February 25, 2021

## **ADDENDUM NO. 1**

### **WASTEWATER TREATMENT FACILITY IMPROVEMENTS (2020) BID REFERENCE SK0032WO FOR THE TOWN OF SOUTH KINGSTOWN, RI**

SK-1

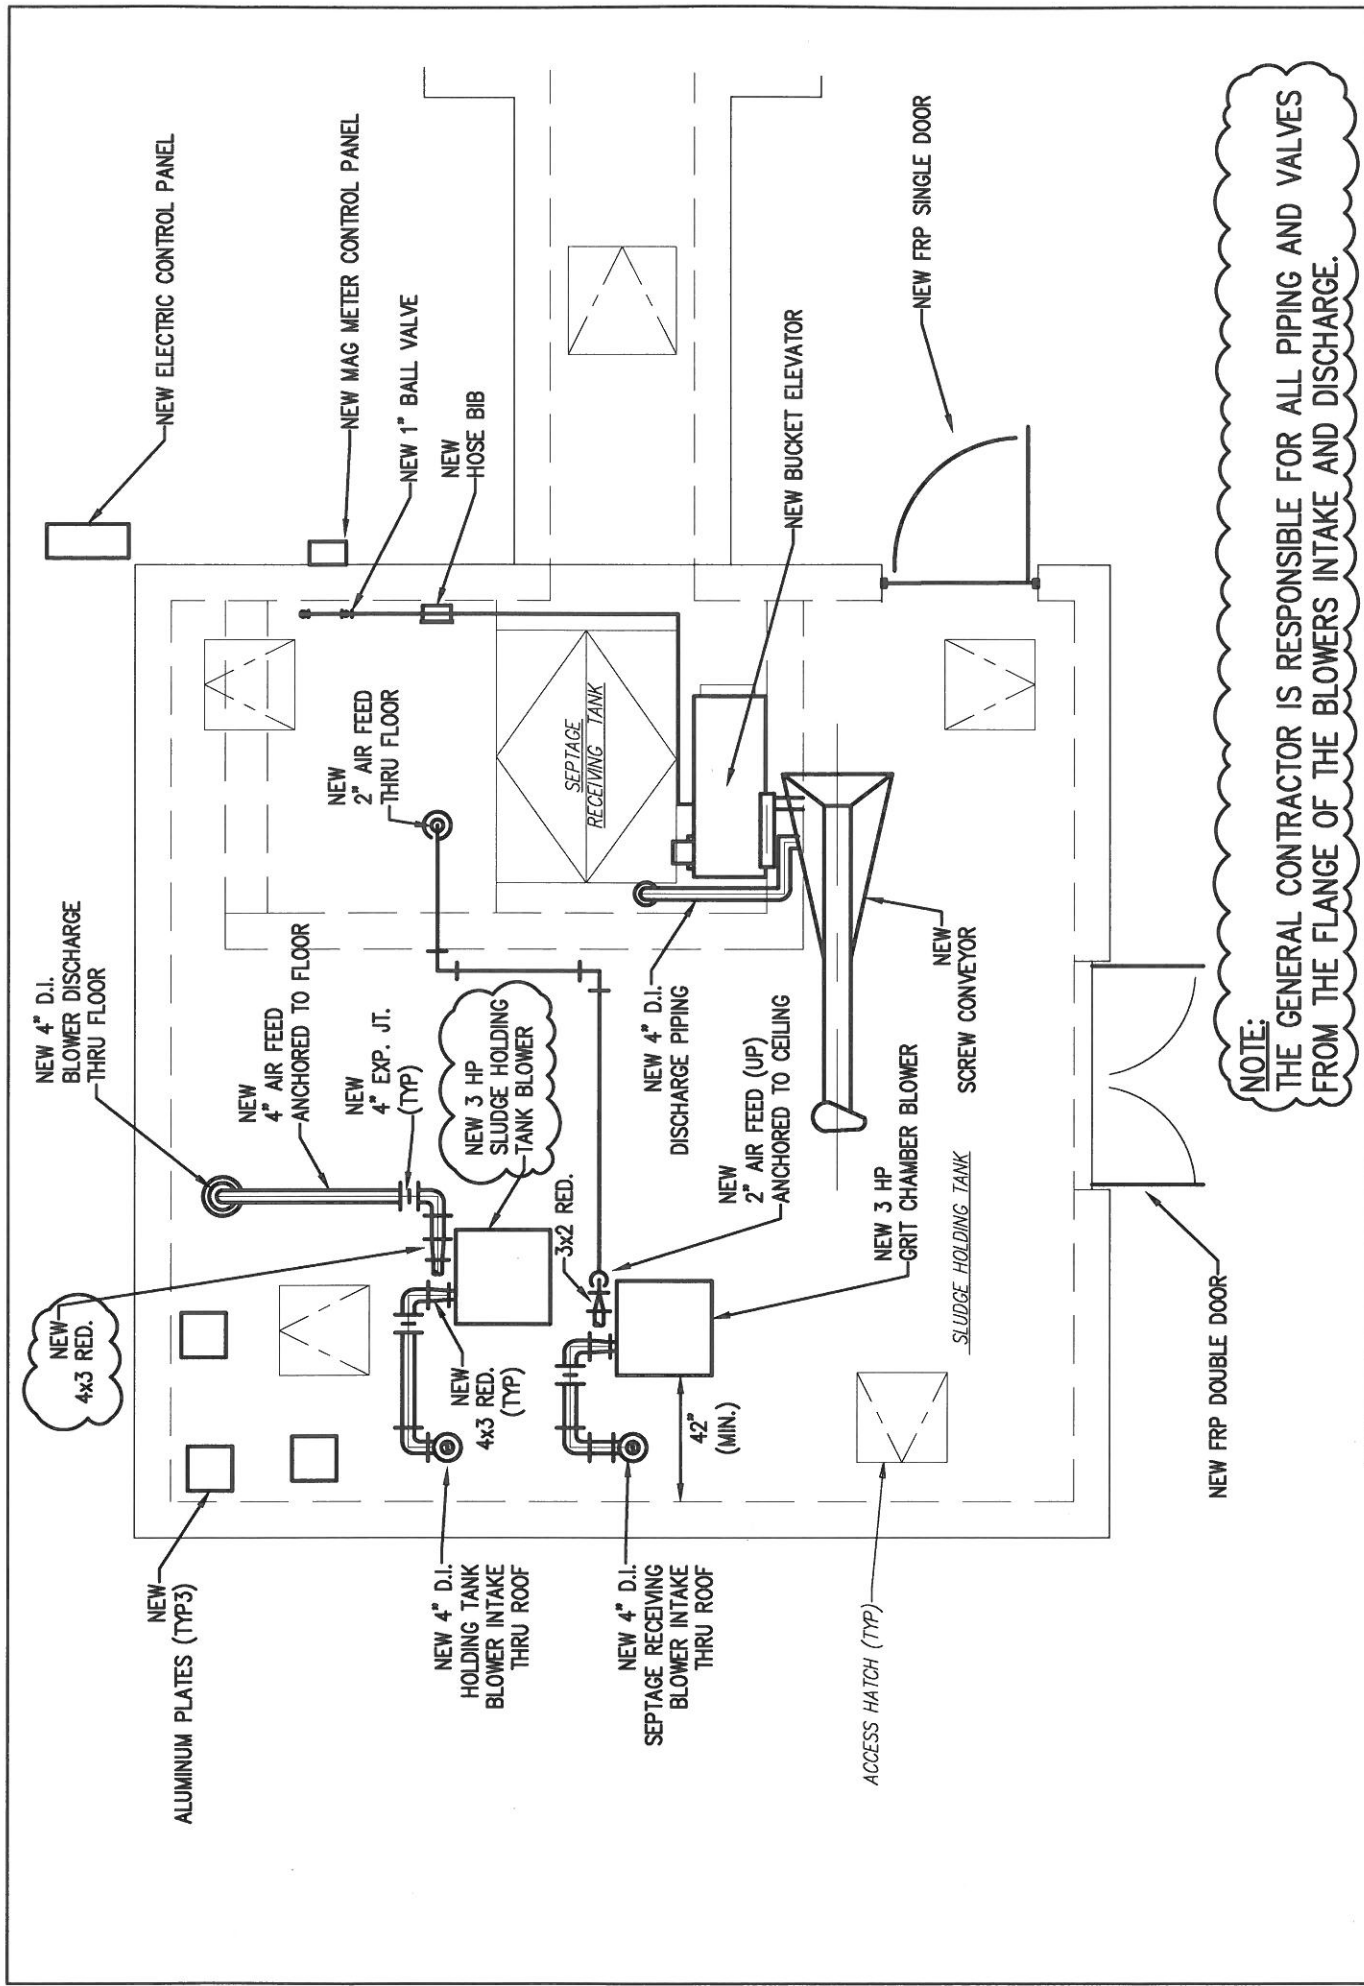
- A. See Sketch SK-1 (attached): requirements for painting polymer area
- B. See Sketch SK-2 (attached): clarification of piping requirements
- C. See Sketch SK-3 (attached): control wiring modifications – slide gates
- D. See Sketch SK-4 (attached): wiring modification – slide gates

**NOTE:**  
 THE GENERAL CONTRACTOR IS RESPONSIBLE FOR ALL PIPING AND VALVES FROM THE FLANGE OF THE BLOWERS INTAKE AND DISCHARGE.
